**SAN ANTONIO WATER SYSTEM  
WEST VIEW TANK REPLACEMENT  
SAWS Job No. 15-6102  
Solicitation No. CO-00047**

**ADDENDUM NO. 3  
March 17, 2016**

**Consulting Engineer: River City Engineering, PLLC  
TBPE Registration No. F-1546**

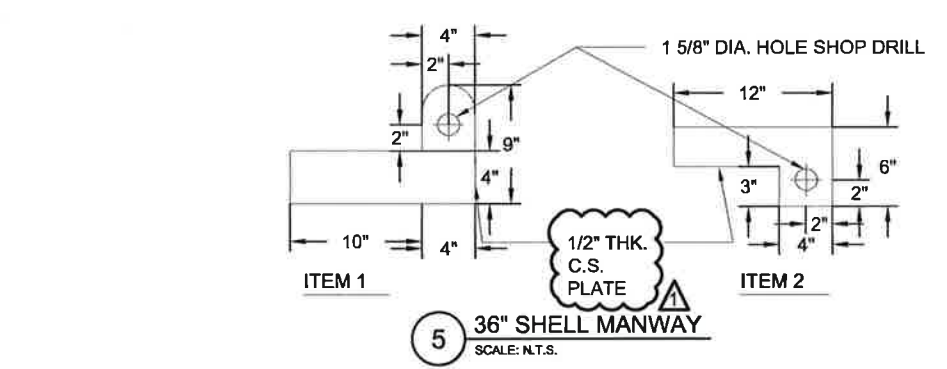
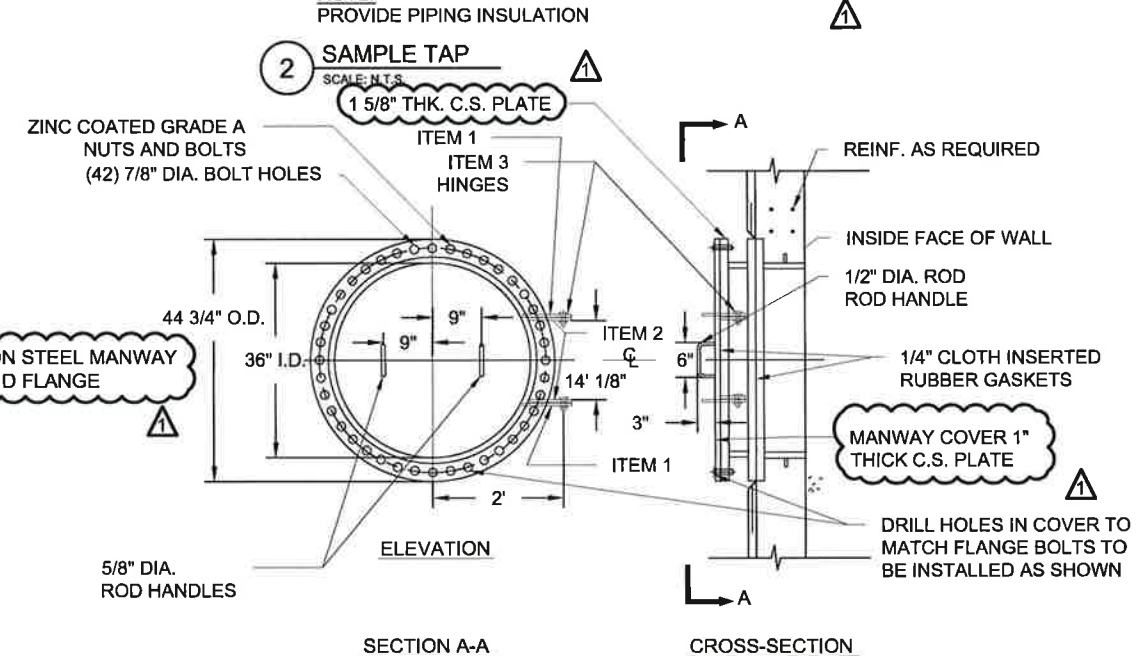
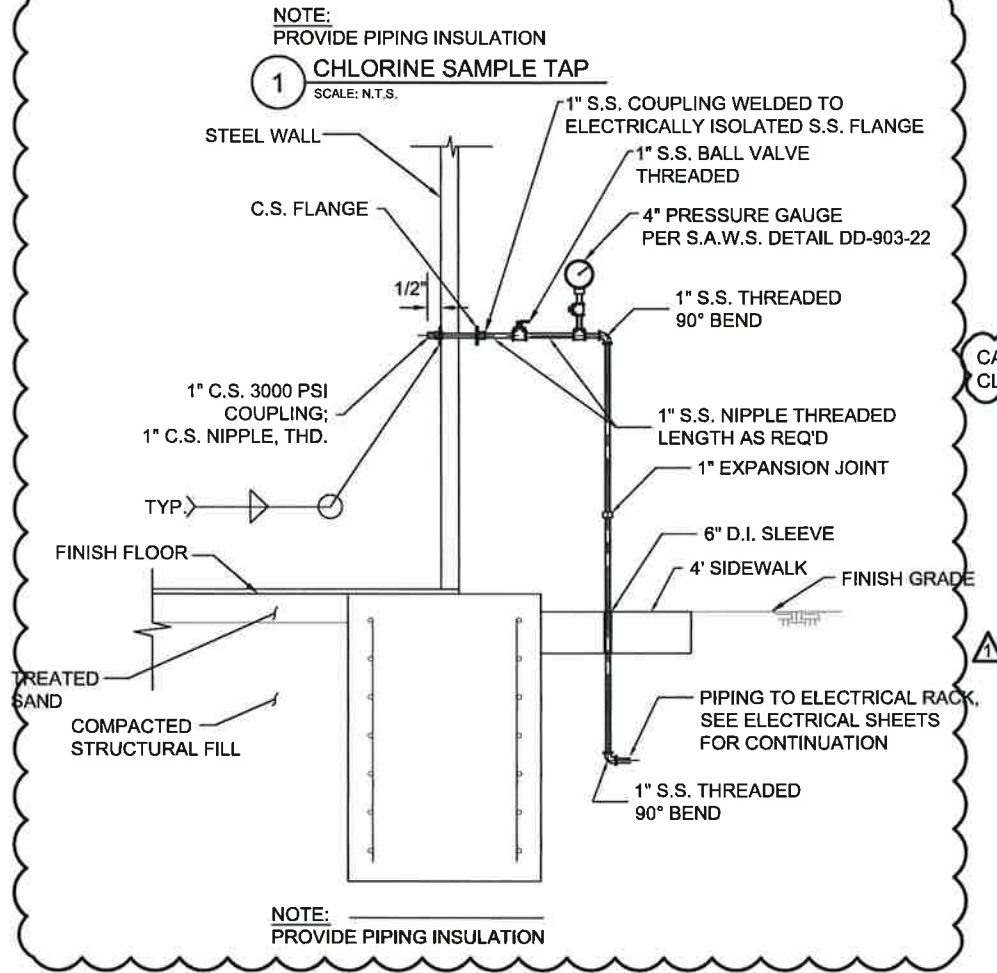
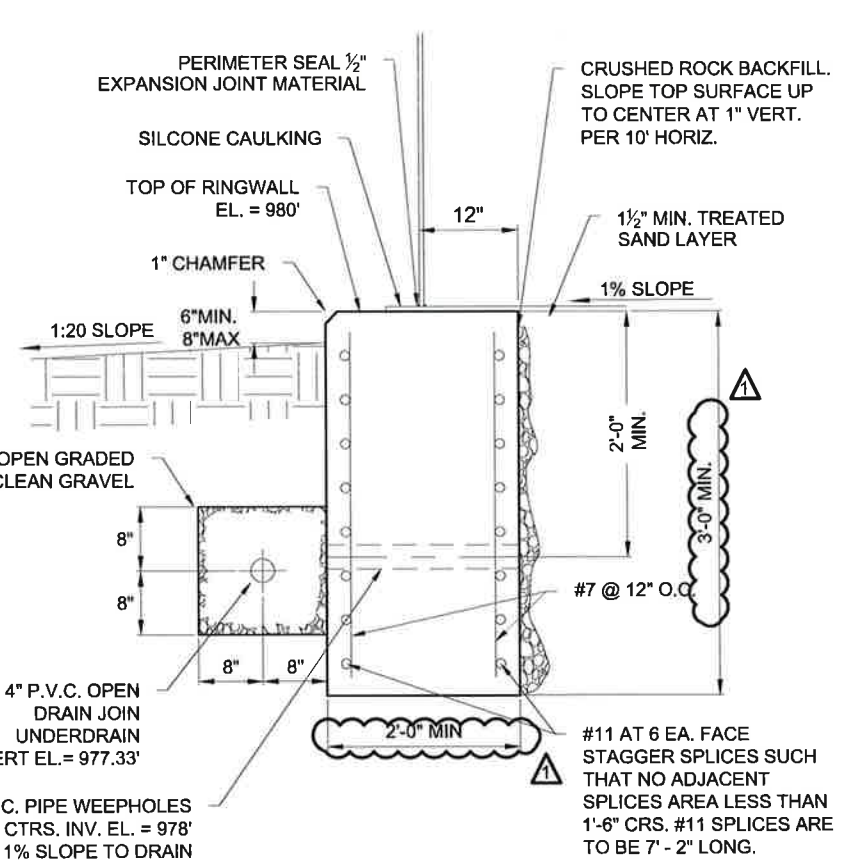
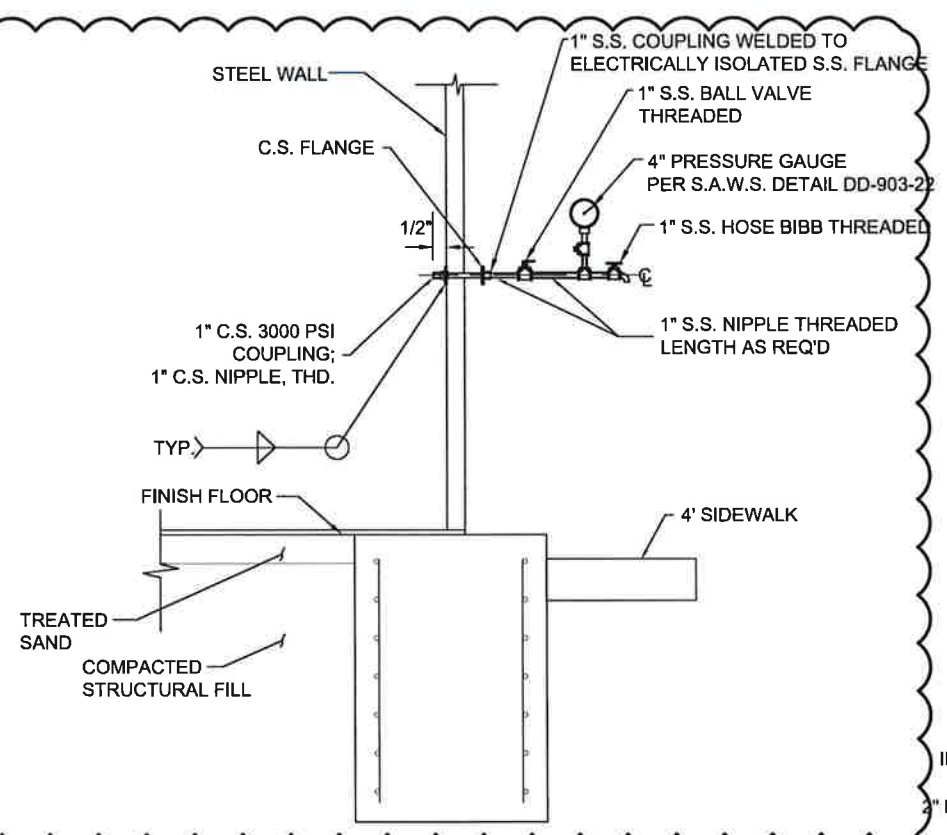
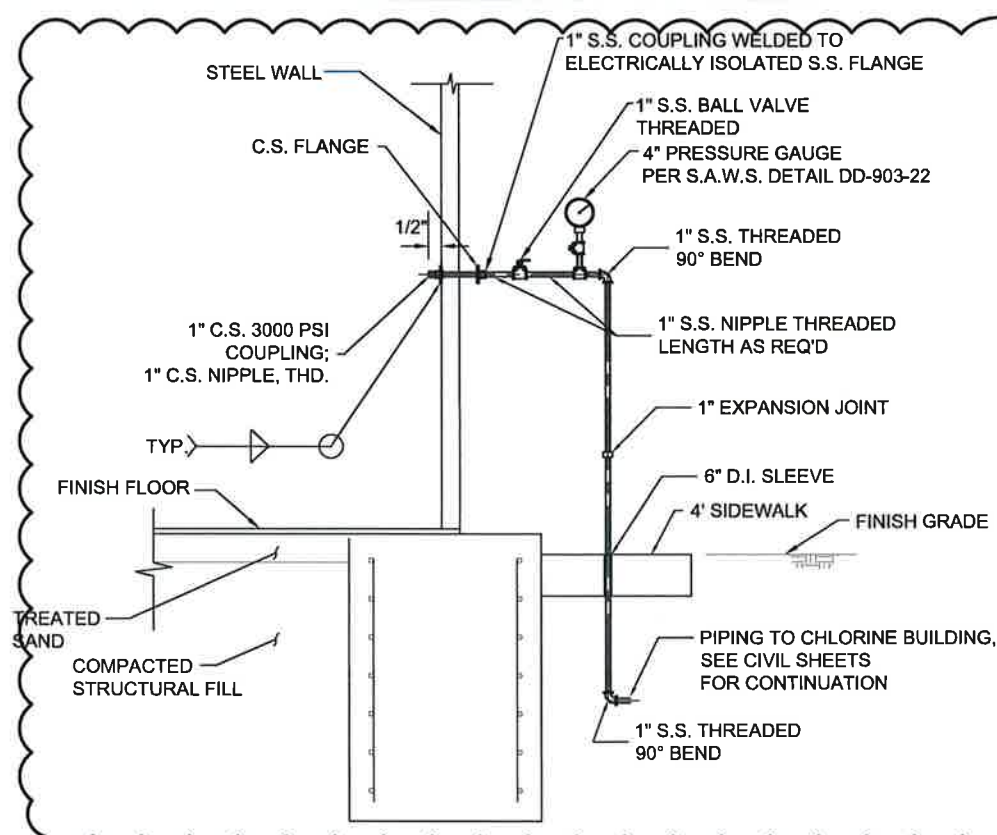
15. Question: The Plans call for the 36" tank shell manways to be fabricated from stainless steel. It is unusual to install a stainless steel shell manway on a carbon steel Ground Storage Tank. Please clarify this is the owner's intention.

25. Question: 13205-5; 2.2 A2 – Shell Manholes: The industry standard 36” shell manway is illustrated and discussed in API – 650. Please verify if the industry standard can be used.

30. Question: Drawing 22 of 30 – Details #1, #2, and #4 – The 1" stainless steel pipe penetrating the carbon steel tank shell will be a galvanic problem. It may be preferable to use 1" carbon steel pipe. Another consideration would be to attach a flanged carbon steel nozzle. A 1" stainless steel coupling would be welded to an electrically isolated stainless steel blind flange.

31. Question: Drawing 22 of 30 – Detail #5 – Please consider using an industry standard 36" shell manway with carbon steel covers and blind flanges.

Response: The 36-inch tank shell manways are to be fabricated from carbon steel only. Please reference Item 60 in the Drawings Section below and attached Sheet T-06 for modifications.

Response: The Shell Manholes shall be provided as specified and as shown in the contract documents. Clarification is also provided in this Addendum. Please reference Item No. 60 in the Drawings Section below and attached Sheet T-06 for modifications.

Response: These details have been modified by the Addendum. Please reference Item No. 60 in the Drawings Section below and attached Sheet T-06 for modifications.
